PROJECT: LIDL - Newcastle Retail Store
SUBJECT: Design Modification Acoustic Impact
FOR: LIDL Ireland GmbH
REF: 22/0557T01
DATE: 2 March 2023

TECHNICAL NOTE

Figure 1 Development Southern Boundary Elevation

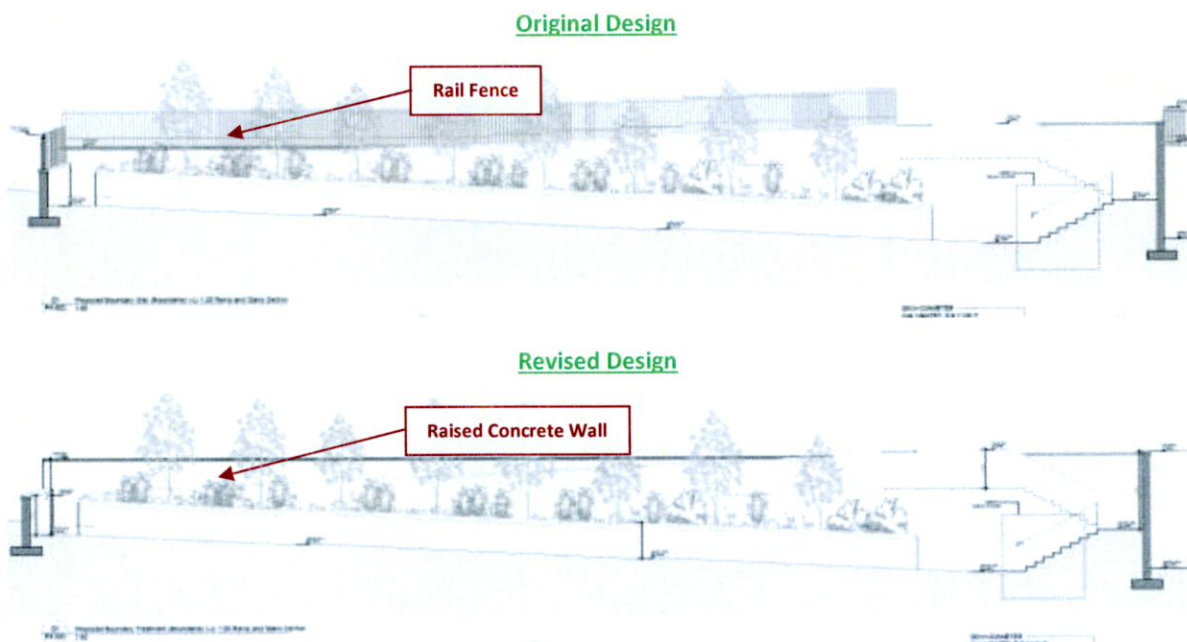
(i) In order to achieve the most optimum amount of noise reduction the wall height at the southern end of the proposed development should be increased in line with the recommendations of the Environmental Health Officer.

1. The Environmental Health Department request that the boundary wall at the southern end of the development be raised above the currently proposed 2 metres. The currently proposed 2-metre high wall provide minimal mitigation against the noise impacts outlined above. In order to achieve the most optimum amount of noise reduction the wall height should be increased to the maximum level to be agreed by relevant engineers and acoustic experts.

Following review of the subject documents, the biggest concern from the Council is seemingly the potential for development noise emissions to impact the future residential development area to the south. In the original design, a 1.2m high rail fence was provided along the top of the concrete retaining wall along the development's southern boundary. In the revised design submission, this boundary has been modified to enhance the solid concrete wall, raising it by up to 600mm.

Given that the ground level of the LIDL development is already significantly below the elevation on the south side of the southern boundary, this enhanced concrete wall will effectively range between 3 - 4 m in height. A noise barrier wall height of this order would be considered both significant and effective in providing appropriate acoustic screening for the development from the future residential development buildings to the south. Although the predicted development noise emission levels in the CLV Noise & Vibration Impact Assessment Report at the future residential area to the south are already well below established best practice guidance criteria, the modification of this wall should reduce development noise emission levels even lower.

The southern boundary rail fence area was enhanced by raising the solid concrete wall up to 600mm. This wall will therefore give an effective noise barrier wall height of 3 - 4m. A wall of

Figure 2 Section through Development Eastern Boundary

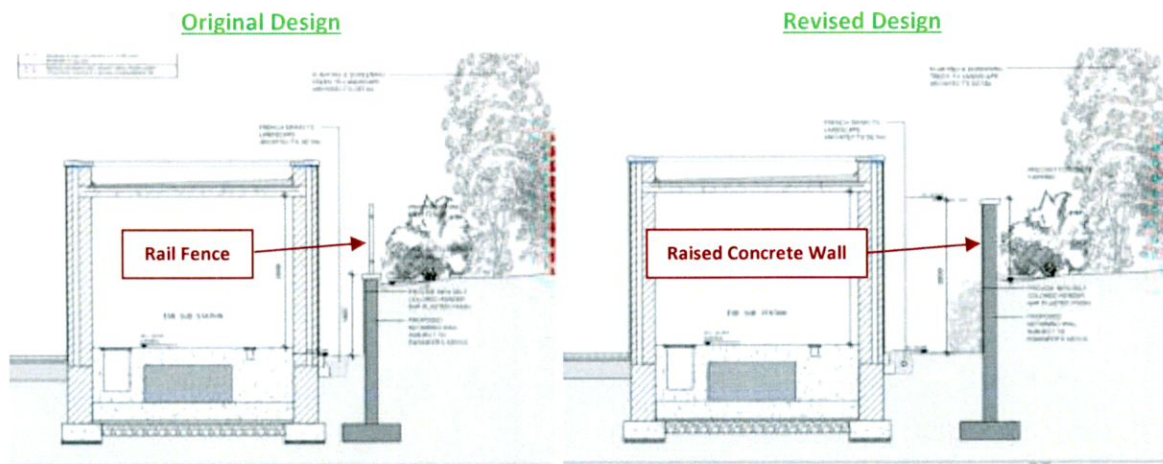
The eastern boundary wall has similarly been enhanced with the concrete wall raised to replace the previous railing detail.

Similarly, the raising of the concrete wall to the east will, in conjunction with the raised elevation at the eastern boundary, create a solid boundary wall that is approximately 2.6m in height. Although the predicted development noise emission levels in the CLV Noise & Vibration Impact Assessment Report at the future residential area to the south are already well below best practice established criteria, The modification of this wall will also reduce predicted development noise emission levels even lower than the predicted levels in the CLV Noise & Vibration Impact Assessment Report (which are similarly within the established best practice guidance criteria) in potential future residential areas to the east.
